Request for Class II Permissive Change

FCC ID: 2AHVO-OZO040101

Date: 11/20/2020

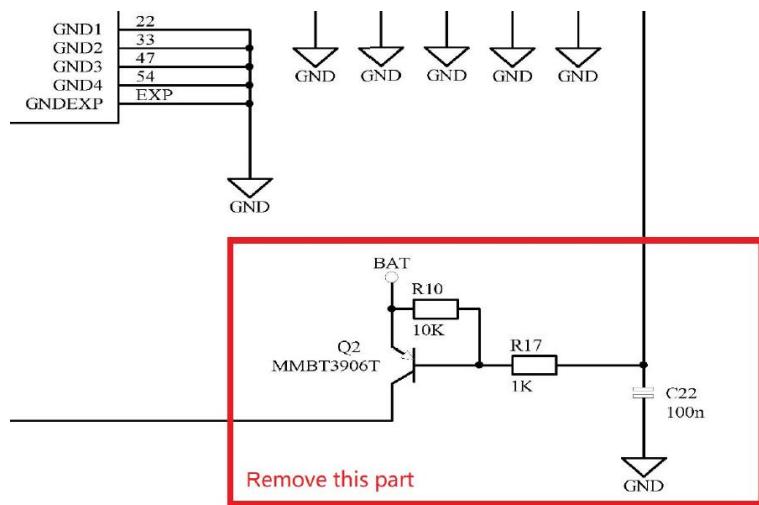
Alternative PCB by removing the below part in old PCB

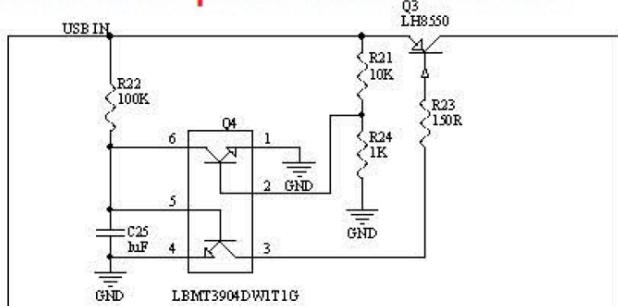
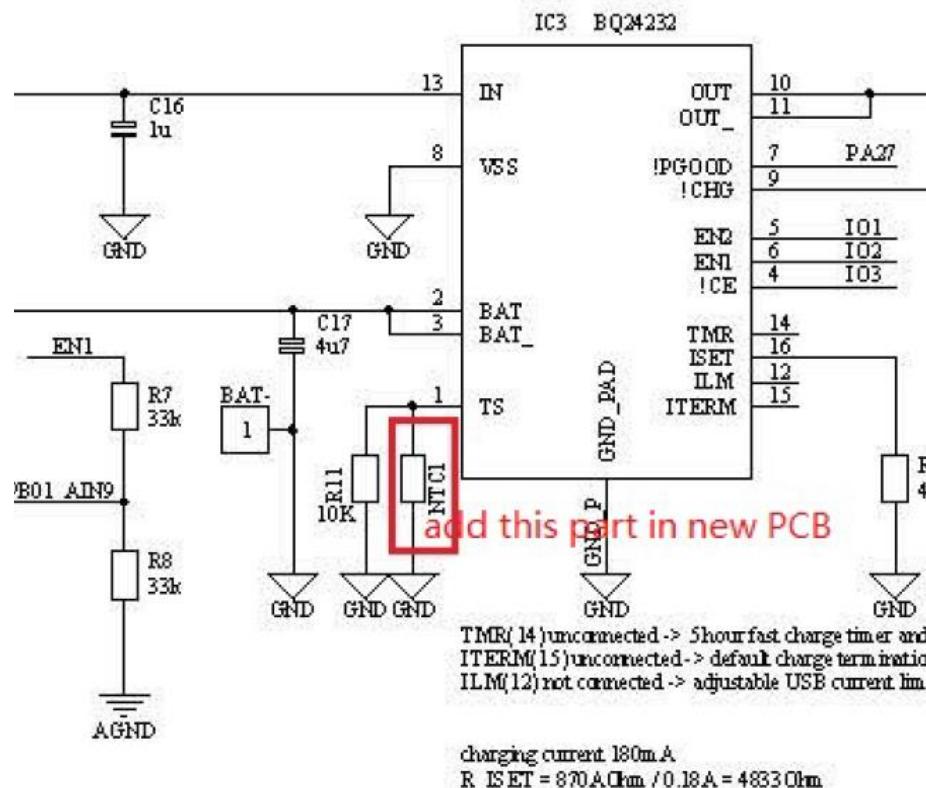
And adding the below parts in the new PCB.

add this part in new PCB

Resistors well matched, 1% or better.
 $G_{av} = 2 * (150k\Omega / R)$
Capacitors X7R or better, 10% or better,
 $C = 1/(2\pi f R^2)$
